Access Compliance Report

Public Rights-of-Way

Intersection ID: 52304	Main Street: IMPATIEN_DR	Cross Street: SNOWBELL_CT	Location: NE
ADA ID: 0583180F1FED	Ramp Type: BlendTrans1	Initial Pass/Fail: Pass	Overall Compliance: No
Severity Score: 20			
Codes/Mitigation Info/Possible Solution		Field Measurements/Component Compliance

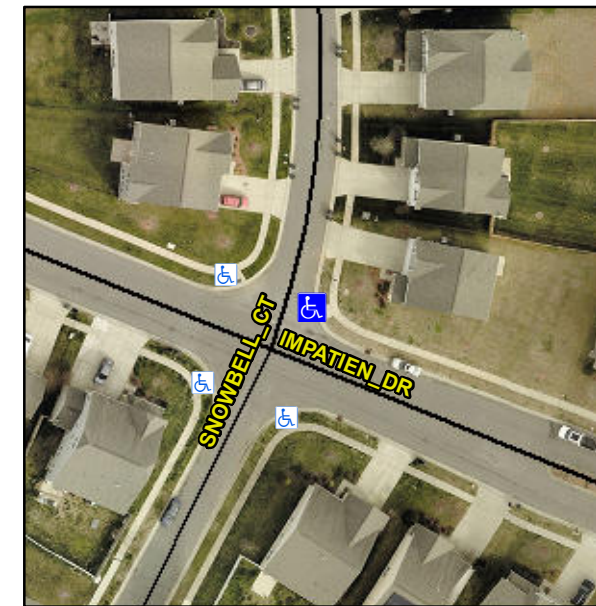
DWS WARPED

Not Found, R304.2.1, R304.2.2-Perp, R304.3.2-Para, R305.2, R302.7, R302.7.2, R304.5.4

Remove & Replace Curb Ramp With Two New Directional Ramps or Equivalent. Remove & Replace Gutter.
